UNION ELECTRIC COMPANY  
1901 GRATIOT STREET  
ST. LOUIS, MISSOURI

ULNRC-423

DOCKET NUMBER 50-483 ~~XXXX~~  
CALLAWAY PLANT, UNITS 1&2  
ENVIRONMENTAL REPORT - OPERATING LICENSE STAGE

Reference: NRC Letter dated Jan. 2, 1981 signed by R. L. Tedesco

FIGURE 1- Copper Solubility

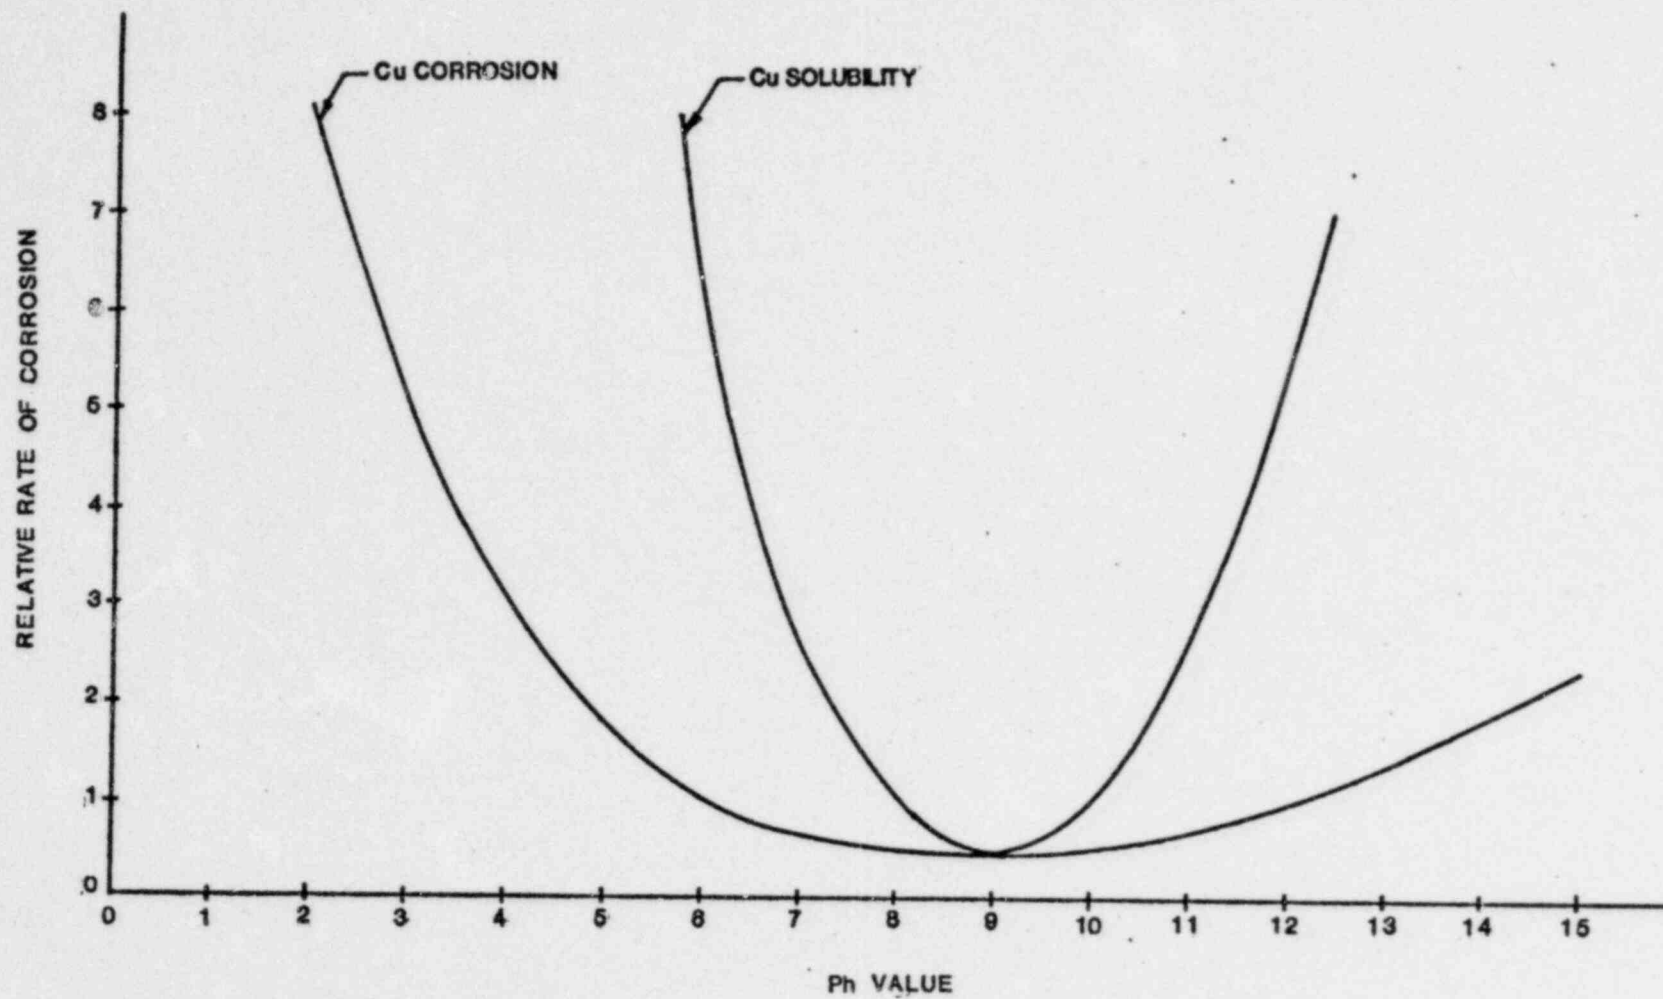
Specify whether the inhibition of scaling by phosphonates will affect the corrosion protection normally afforded by slightly scaling conditions (positive saturation index). Provide a quantitative discussion of the effects that the phosphonates may have on the soluble fractions of heavy metals (such as copper, nickel) cooling system corrosion products and the resultant impact on discharge water quality and receiving water biota.

As shown on the attached Figure 1, by operating in a pH range of 7 to 10, the corrosion rate for copper alloys will be at a minimum and, therefore, the levels of soluble copper in the recirculating water will be at a minimum. Betz outlined in their proposal a monitoring system as part of their normal service program. Copper was one of the parameters listed to be monitored.
